ENVIRONMENTAL PROTECTION AGENCY

40 CFR Parts 51, 60, 61, and 63

Test Methods and Performance Specifications for Air Emission Sources

ACTION: Proposed rule.

Figure 7. Maximum Number of Required Traverse Points

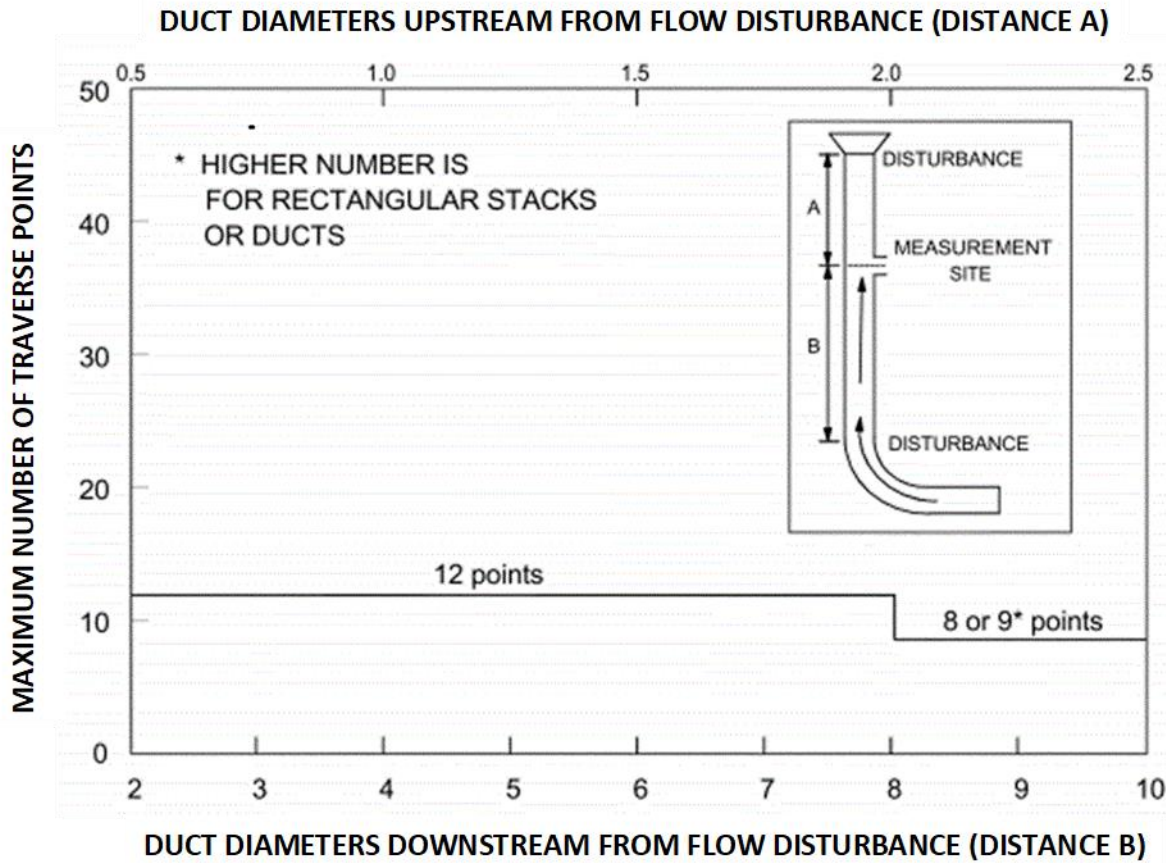
In Method 201A, section 1.2, the erroneous gas filtration temperature limit of 30 °C would be revised to 29.4 °C. In section 1.6, the erroneous word “recommended” would be corrected to “required.” Section 6.2.1(d) would be revised to allow polystyrene petri dishes as an alternative to polyethylene due to the lack of commercially available polyethylene petri dishes. The polystyrene petri dishes offer similar chemical resistivity to acids and inorganics as polyethene and have been shown to transfer extreme low residual gravimetric mass to filters when used in ambient air applications. In section 8.6.6, the erroneous stack temperature of ± 10 °C would be revised to ± 28 °C. In section 17.0, the erroneous caption for Figure 7 would be corrected from “Minimum Number of Traverse Points for Preliminary Method 4 Traverse” to “Maximum Number of Required Traverse Points,” and the erroneous y-axis label would be corrected from “Minimum Number of Traverse Points” to “Maximum Number of Traverse Points.”

2. Revise sections 1.2, 1.6, 6.2.1(d), and 8.6.6 and Figure 7 in Method 201A of appendix M to part 51 to read as follows:
